John Skirving
Kier Construction Ltd
Former LBR Trolley Bus Depot,
501 Ley Street,
Ilford, Essex. IG2 7QZ

Your reference: Abacus Belsize Primary School – Response to the objection queries.

Our reference: PC-14-0368-LT2

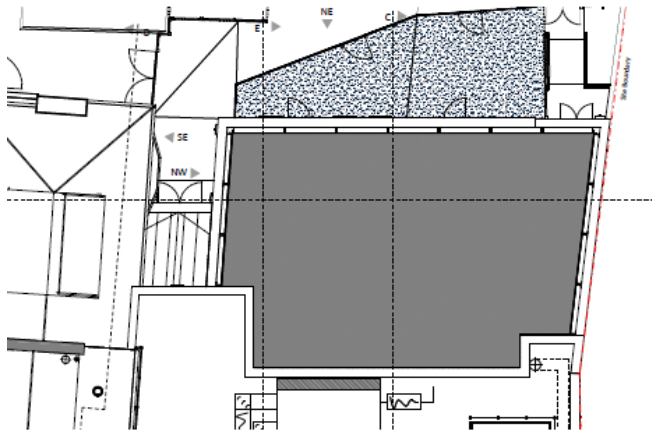
- It is not clear from the report where the source is assumed to be located – in the yard or on the play deck. There is no indication as to whether the source relates to one or several children or whether it relates to maximum noise levels or the equivalent continuous sound power;

- The fact that the whole yard is available as a play area could mean that the source is actually closer to residential properties and windows than shown on page 7;

The sound power is calculated as an area source instead of individual point sources, which we believe is the right assumption to make in this type of assessment. The play area located on the roof has an area source of 147 m², and the play area located on the yard has an area source of 50 m². The figure overleaf shows the location of the play areas included in our calculation, the location is extracted from drawing 114031 - P106.

The source is treated as an area source instead of individual point source. As we have commented above the play area located on the roof has an area source of 147 m², and the play area located on the yard has an area source of 50 m². Page 3 of our report refers to the noise source used in the calculation, this is similar to raised voices. The sound power is equivalent continuous and not maximum sound power.

The above assumption is incorrect; the architectural drawings clearly identify where the play areas are proposed.
